CITY OF FRANKLIN

REPORT TO THE PLAN COMMISSION

UDO Text Amendment, Special Use and Site Plan

Project Name:	Firestone Complete Auto Care UDO Text Amendment, Special Use and Site Plan
Project Address/Tax Key:	10800 W. Speedway Drive/704 1012 000
Property Owner:	Menard, Inc.
Applicant:	Pavilion Development Company
Current Zoning:	M-1 Limited Industrial District
2025 Comprehensive Plan:	Commercial
Action Requested:	Recommendation of approval of the UDO Text Amendment and Special Use and approval of the Site Plan Application

SHEET NUMBER:
C7.1

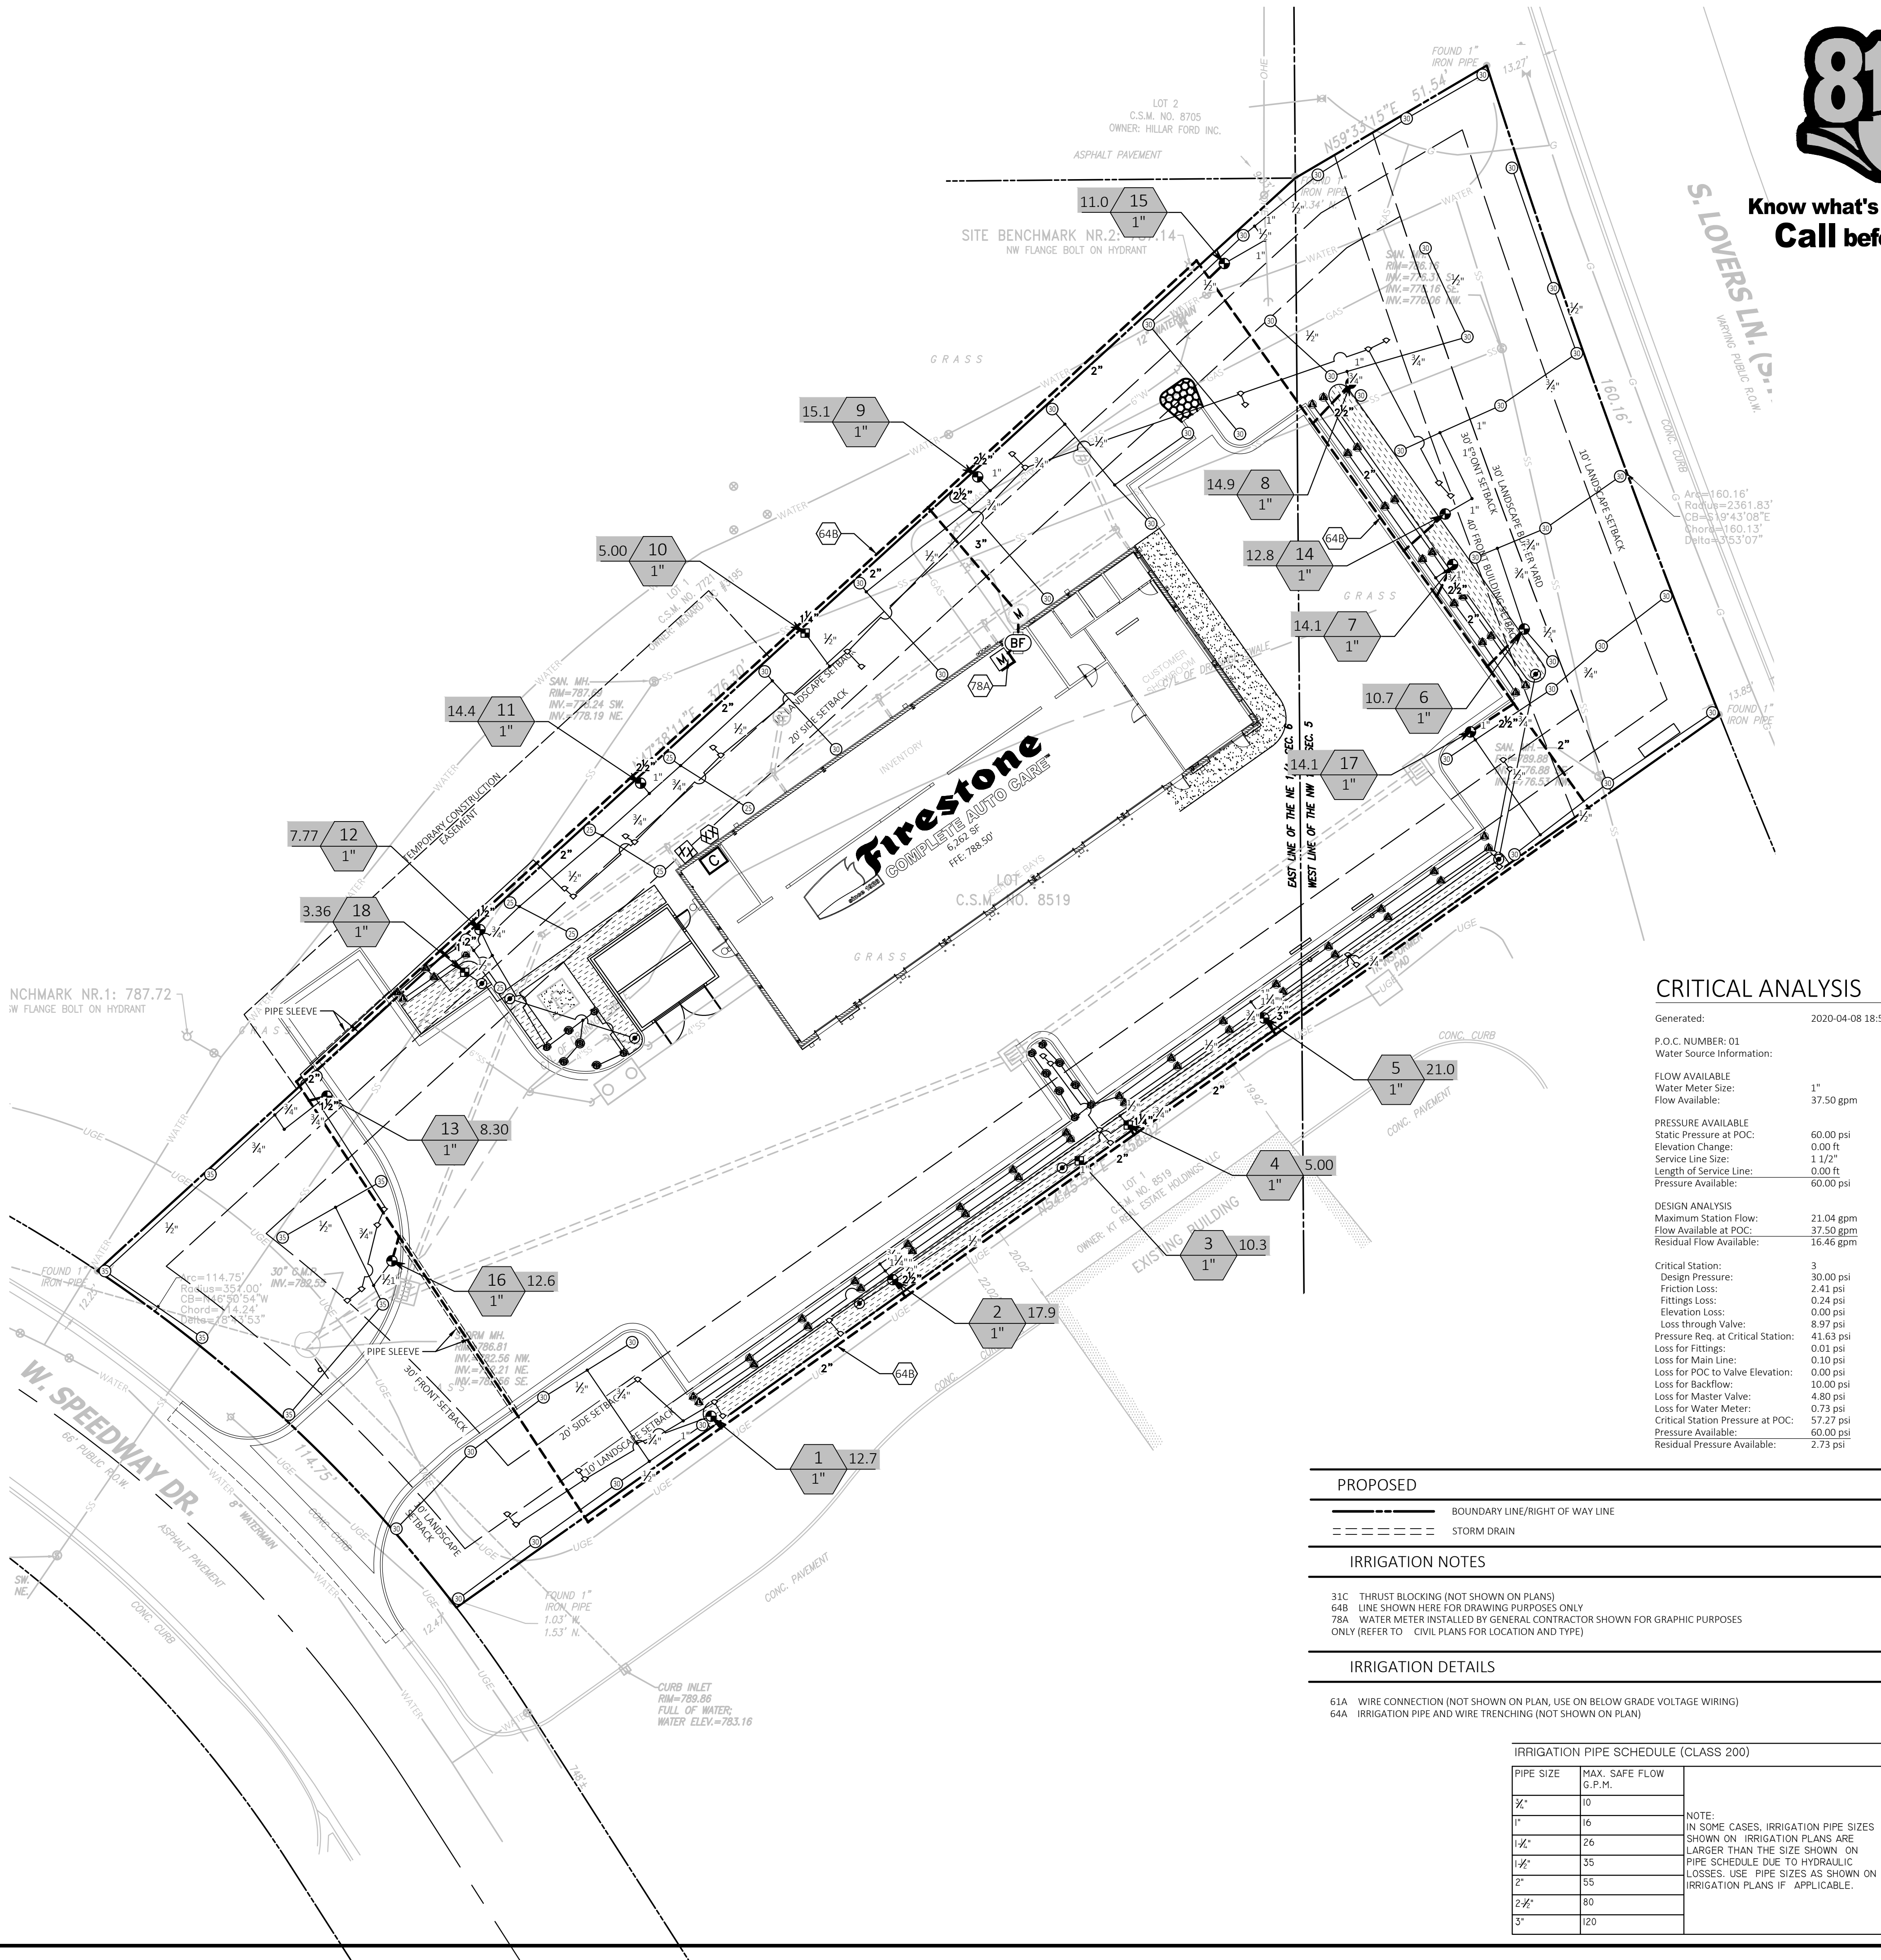
6. The Landscape Plan includes one sheet of the Site Intensity and Capacity Calculations according to the procedure in DV 15-3.0500 (<https://ecode360.com/33224849>)

8. Please provide landscape screening around the transformer pad as may be possible.

9. Please provide a 30-foot Landscape Buffer yard Easement adjacent to South Lovers Lane Road (S.T.H. 100). Note that no structures shall be allowed within this easement.

10. Please show areas for snow storage on the Landscape Plan in accordance with Section 15-5.0210 of the UDO.

11. Please list plantings by type in Plant Schedule (Canopy/Shade Trees, Evergreens, Decorative Trees, and Shrubs). The UDO requires seven plantings of each type based on 32 parking spaces provided. Please demonstrate that this requirement as well as the minimum planting size requirements are being met.

13. Please provide irrigation in compliance with Section 15-5.0303D. of the UDO and note the method of irrigation on the Landscape Plan.

14. A minimum 2-year planting guaranty is recommended and should be noted on the Landscape Plan (see Section 15-5.0303G.3. of the UDO).

Acknowledged. Landscape plan has been revised to include the all required tables per comment.

Acknowledged. Landscape plan has been revised and landscape screening provided around the transformer.

Acknowledged. 30-foot landscape buffer is shown on the plan.

Acknowledged. Snow storage areas as required by UDO have been shown on the Landscape Plan.

Acknowledged. Landscape Schedule has been revised per comment.

Acknowledged. Irrigation plan provided.

Acknowledged. Note added to the plans
